Number	Chapter	Table	Page	Figure	Date	Commenter	Comment	DW response	Response	Commenter doc name
8-167	8				6/11/2019	Virsik	Given the GSA has access to the MCWRA records, it can and must do the same comparison for the limited number of 180/400 eWRIMS statements. Chapter 8 draft Table 8-9. It's simple, yet necessary to meet the "best available" standard. And it leads to a better and more reliable real-world outcome based on accurate water use / yield numbers. No part of the comparison involves determining any "water right" or claim thereto.		The GSP acknowledges the potential double counting of extractions, and identifies this as an uncertainty in the water budget. Because of the many uncertainties in the historical water budget, it was determined that attempting to identify all double counting was not cost effective. The cost effective approach is to refine the water budget with the SVIHM when it becomes available. The SVIHM does not double count surface water diversions and groundwater pumping. This is the approach specifically identified in the GSP.	Public Comments, Tom Virsik, Chapter 6 cc'd Derrick Williams

Subject: **Preliminary Comments Regarding Salinas Valley Basin Groundw

Figure 3-10: Locations of CASGEM Wells in the SVIGSP Area

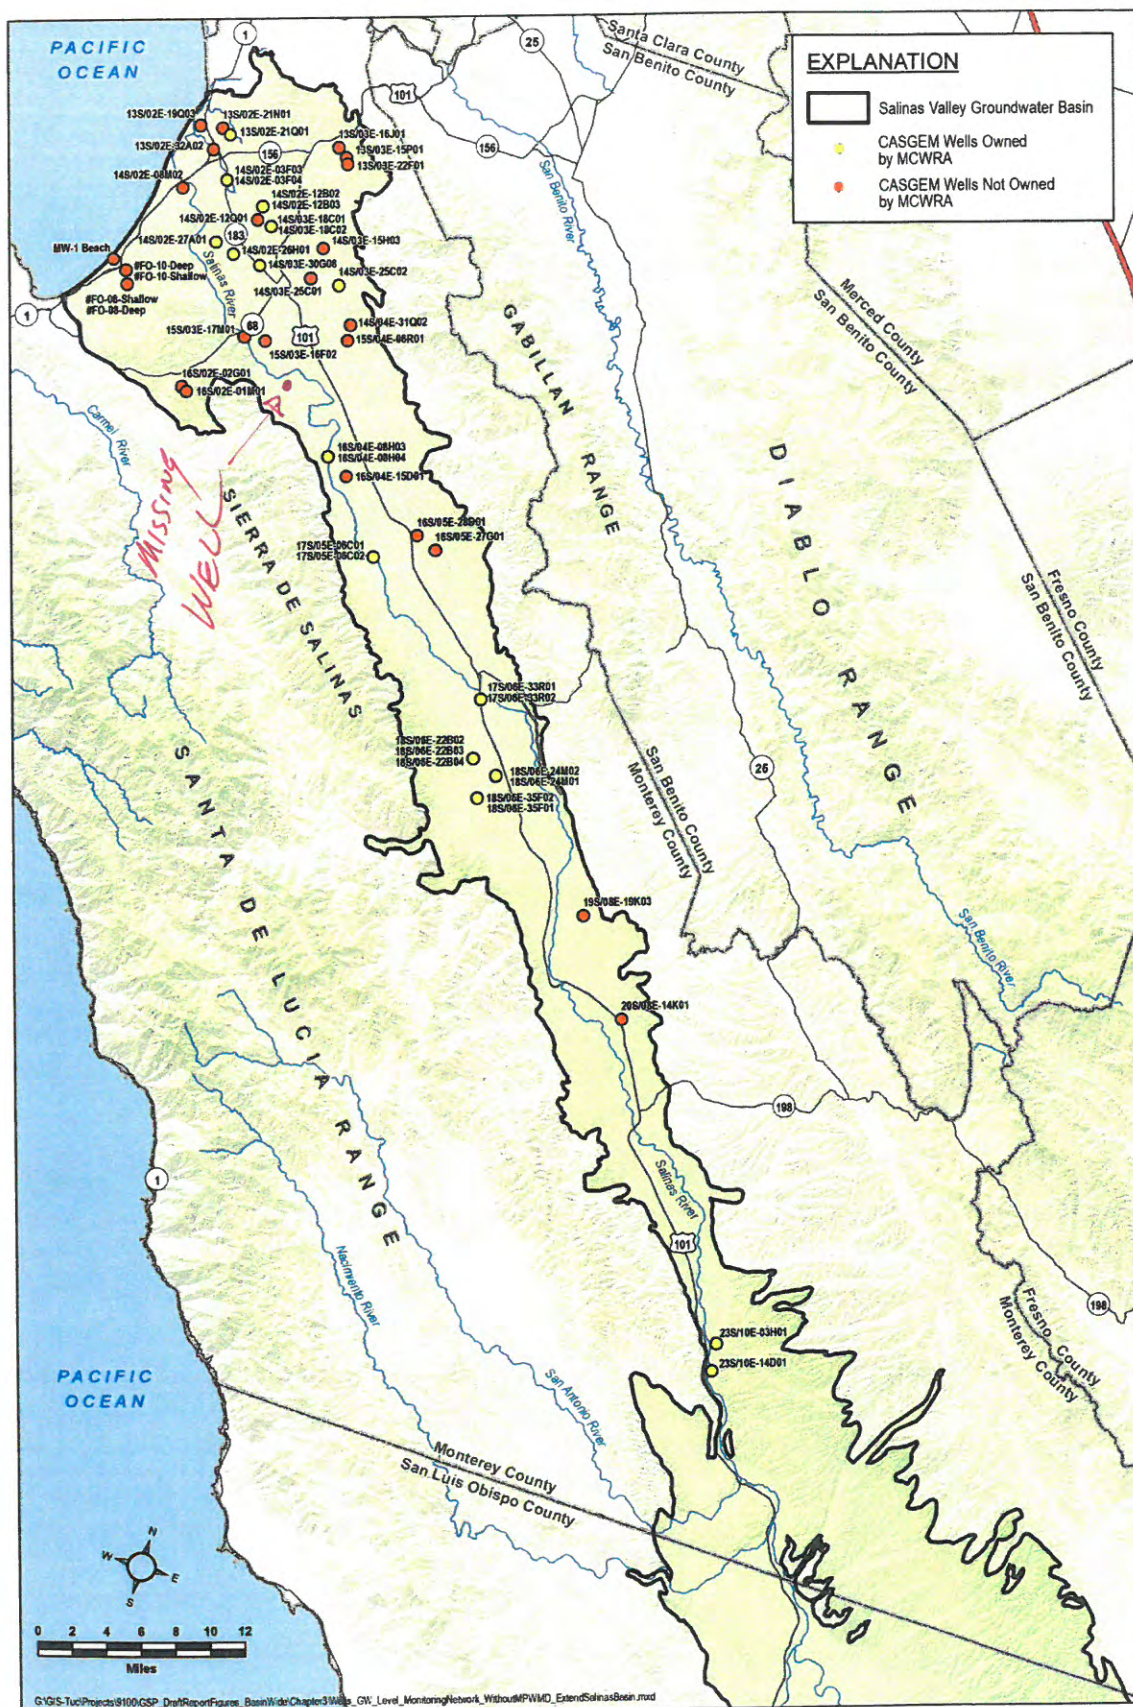
SAME COMMENTS
AS 180-400 GSP

Page 14, Figure 5-6, Figure 5-11 and Appendix 5A: hydrograph confidentiality.

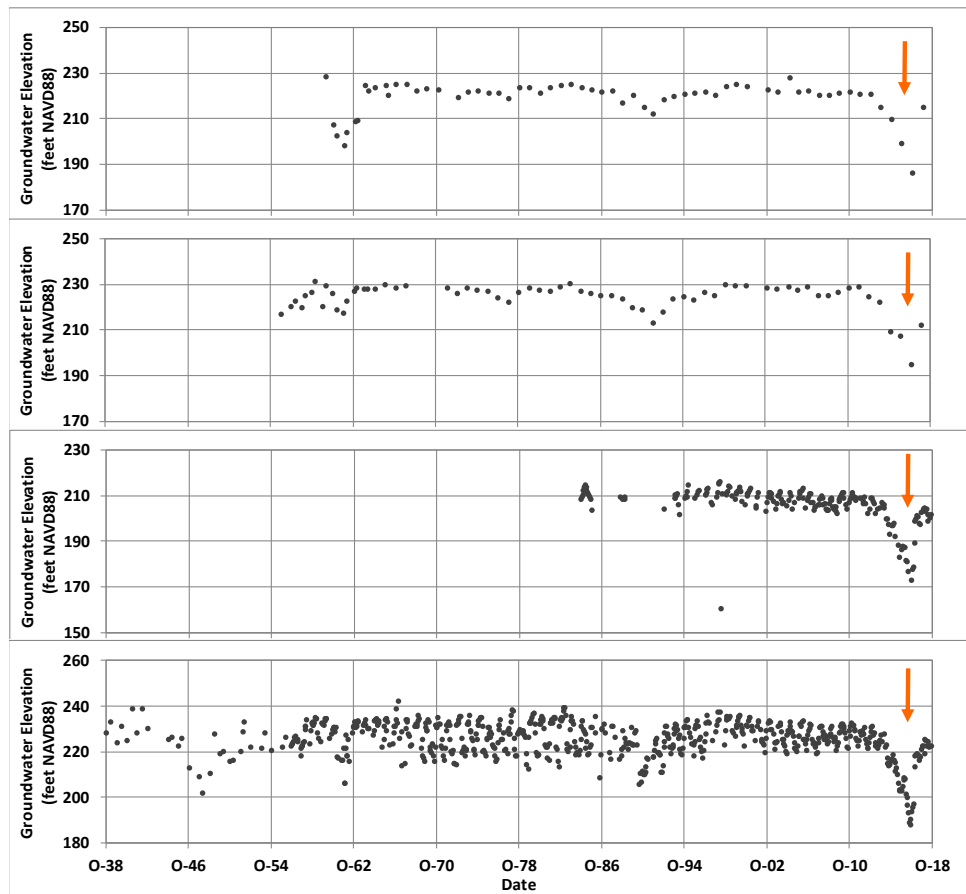
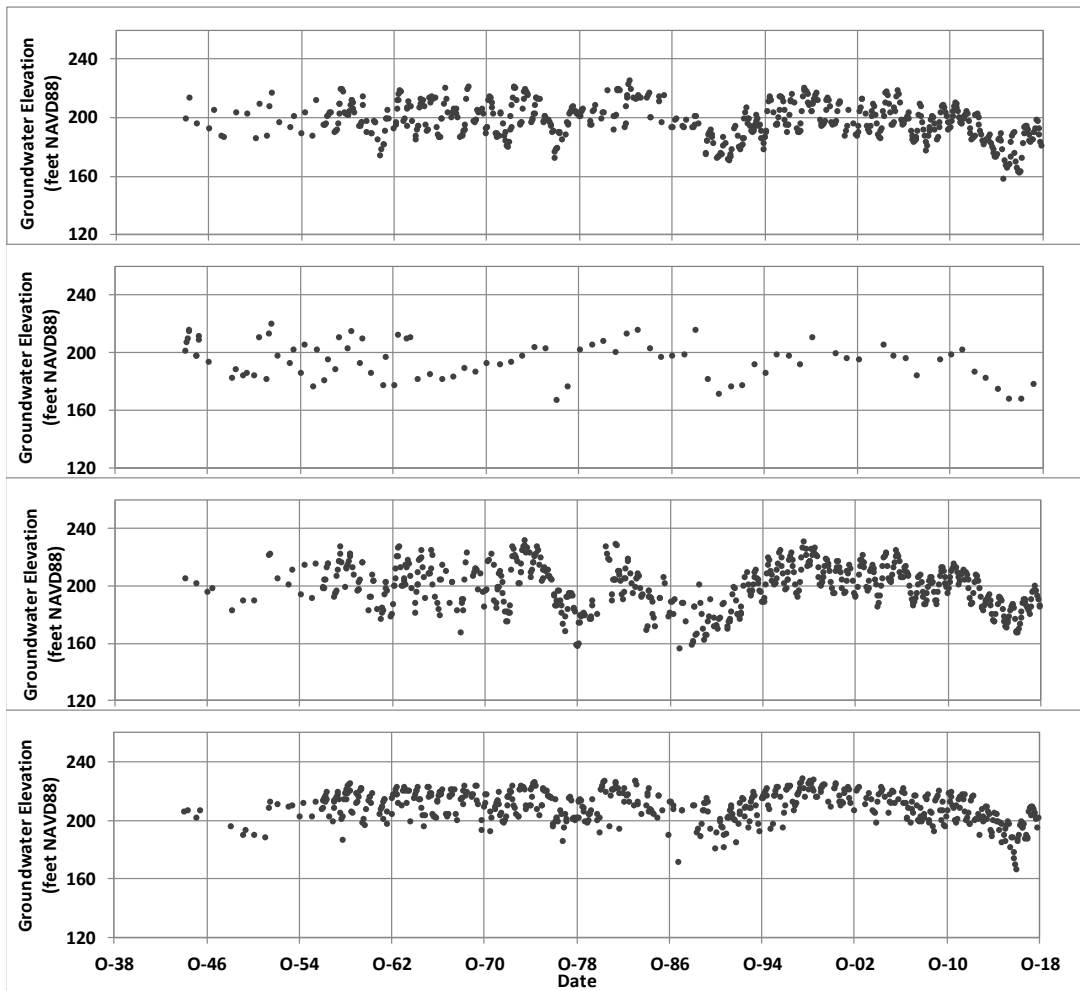
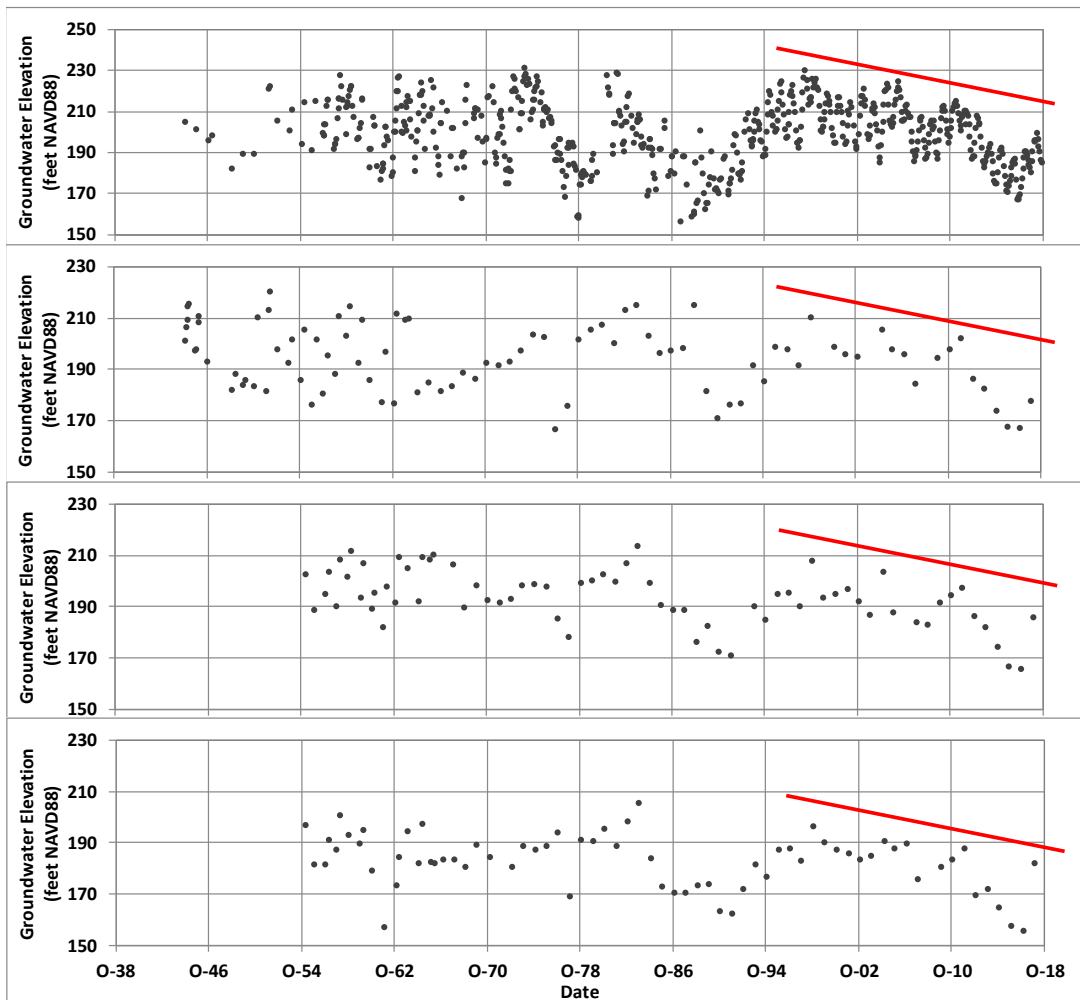
Confidentiality does not preclude presenting hydrographs in reports, provided the well is not exactly identified. By limiting the presentation of data and discussion to only eight wells (Figure 5-6) or 55 wells (Figure 5-11 and Appendix 5-A) out of the 760 locations where MCWRA has collected water levels is unnecessarily selective excluding the data. In particular, the Forebay and Upper Valley Subbasins are underrepresented in the figures and discussion. Groundwater conditions in the Forebay Subbasin cannot be represented by a single hydrograph, as Figure 5-6 implies. By selectively excluding the data, the report fails to identify and disclose local variations in hydrograph patterns that provide important understanding of the relative influence of various recharge sources and, hence, which variables are important for groundwater management. In general terms, the report does not provide adequate granularity of data analysis, and hence may not correctly reflect groundwater conditions in these subbasins.

Groundwater conditions in the Forebay Subbasin are not homogeneous, as the draft chapter implies. Wells close to the Salinas River have hydrographs with pronounced declines during 2013-2016, as illustrated by these four hydrographs:

In contrast, water levels in the following set of four wells higher up on the Arroyo Seco Cone show greater seasonal variability but little cumulative decline during 2013-2016:

Finally, several wells on the northwestern flank of the Arroyo Seco Cone have declining trends since 1990 that are probably related to intensified local pumping to supply new vineyards in the hills to the west where well yields are poor (see hydrographs, below).

These details matter. The broad brush presentation of water levels in the draft chapter conceals local variability that is relevant to sustainability and management actions.

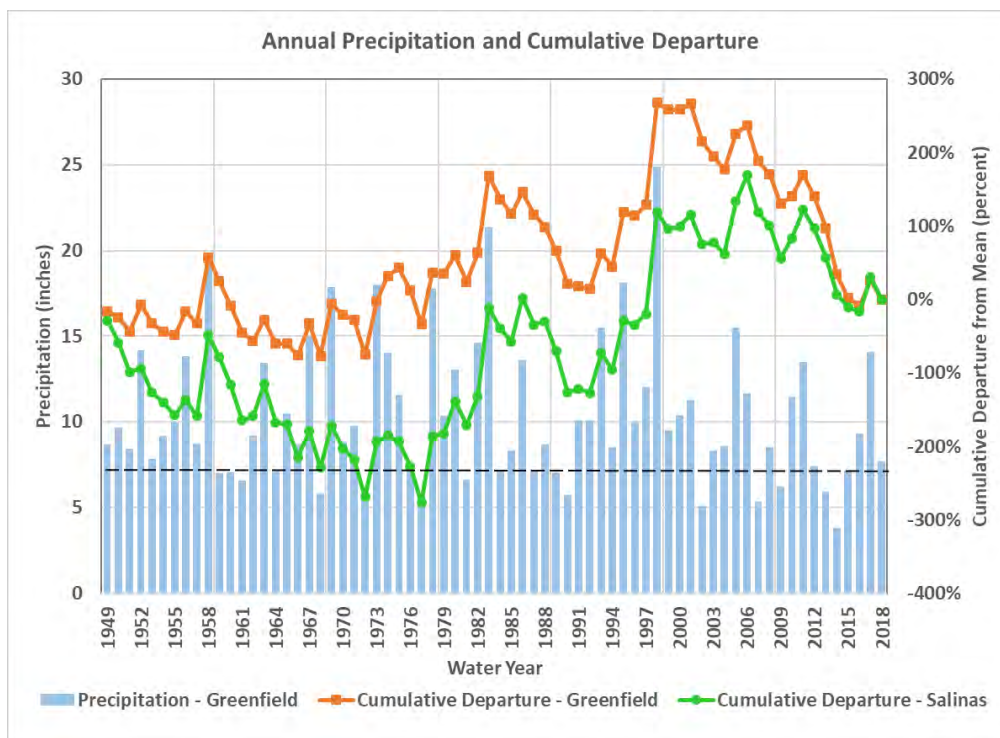
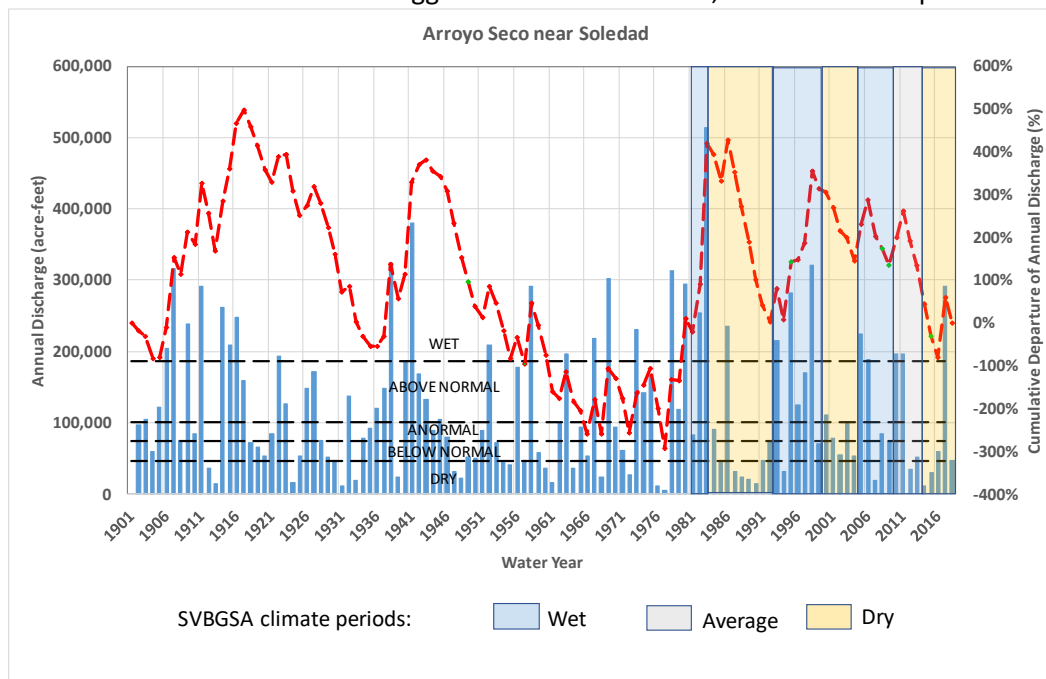
Page 21, 1st paragraph. Water year types. The water year types shown as background in Figures 5-7 through 5-10 are based on a Standardized Precipitation Index methodology that this report does not document but that is described in the 180/400 Foot Aquifer and Paso Robles Subbasin draft GSPs. The SPI method using a 5-year backward average of annual precipitation does not adequately represent wet and dry periods related to groundwater for two reasons. First, groundwater levels correlate more closely with runoff than with rainfall. The standard practice for hydrologic analysis in California is to identify wet and dry periods on the basis of cumulative departure plots. The SPI method is seldom, if ever, used. For example, cumulative departure of annual rainfall at Greenfield and Salinas are shown in the graph below. For both stations, missing data were filled by correlation with nearby gauges to ensure a complete record. Both stations show that the wet period culminating in 1998 was a larger event than the wet period culminating in 1983.

However, groundwater levels in almost all Forebay wells were higher in 1983 than in 1998. This suggests that recharge was greater during the earlier event. A cumulative departure of annual discharge in Arroyo Seco—which is unregulated—reveals that with respect to streamflow the 1983 event was bigger than the 1998 event, as shown in the plot below.

The stronger correlation between runoff and groundwater levels means that cumulative departure of annual Arroyo Seco discharge represents climatic periods better than cumulative departure of rainfall and should therefore be preferred for use in groundwater analysis and planning.

The second weakness of the SPI method is that the 5-year averaging method misses the correct starting and ending years of wet and dry periods. To illustrate, the wet, dry and average (or fluctuating) periods shown in Figures 5-7 through 5-10 of draft Chapter 5 are transcribed onto the cumulative departure of Arroyo Seco discharge, above. The 1984-1992 dry period starts two years too early (1987 was the first dry year of that drought). Similarly, the first two years and the last year of 1993-1999 were not wet. The wet period would more accurately be identified as 1995-1998. 2005 and 2006 were wet, but they did not amount to a large wet period. It might be more useful to simply classify 2005-2011 as variable. The Arroyo Seco cumulative departure plot shows the recent drought as comprised of 2012-2016. The SPI approach adds 2011 and omits 2014-2016 from that sequence, thereby significantly underrepresenting the actual duration and severity of dry conditions.

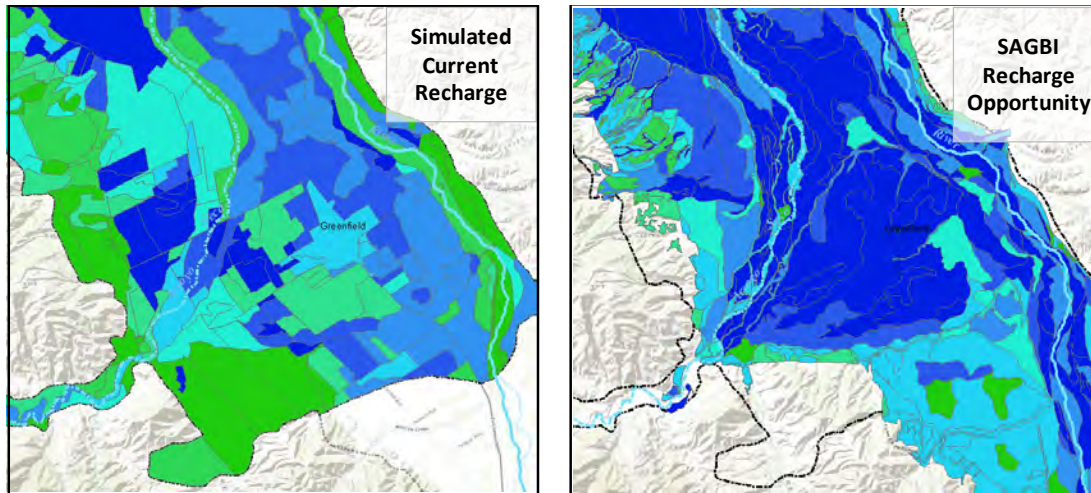
Locations of Recharge. GSPs are required to include maps of recharge locations, and such a map should also be included in the Valleywide Plan. Based on draft materials for the Paso Robles and 180/400 Foot Aquifer GSPs (prepared by the same consultant team), it is likely that the SAGBI map of recharge opportunity would be used for that purpose. However, the SAGBI map is not a map of where recharge currently occurs. It is a map of favorable locations for percolating water at high rates through the soil zone only. The two are not the same. Dispersed recharge through soils typically occurs at rates well below soil permeability and is determined more by the water balance of the root zone than by permeability. If infiltration of rainfall or applied irrigation water raise the water content in the root zone to above its storage capacity (root depth x available water capacity), then excess water will percolate downward and eventually reach the water table. Thus, dispersed recharge occurs wherever rainfall or irrigation occur, which is essentially the entire land surface overlying the Basin. The maps below compare current recharge in the southern part of the Forebay Subbasin simulated using a recharge-runoff-rainfall model (continuous, daily soil moisture budget simulation averaged over 1997-2008) with the SAGBI recharge opportunity map.

Both maps are color scaled so that green is low and dark blue is high. The simulation of current conditions shows the large differences between non-irrigated vegetation, truck crops, vineyards and urban areas. The SAGBI map reflects primarily soil characteristics. The two are very different.
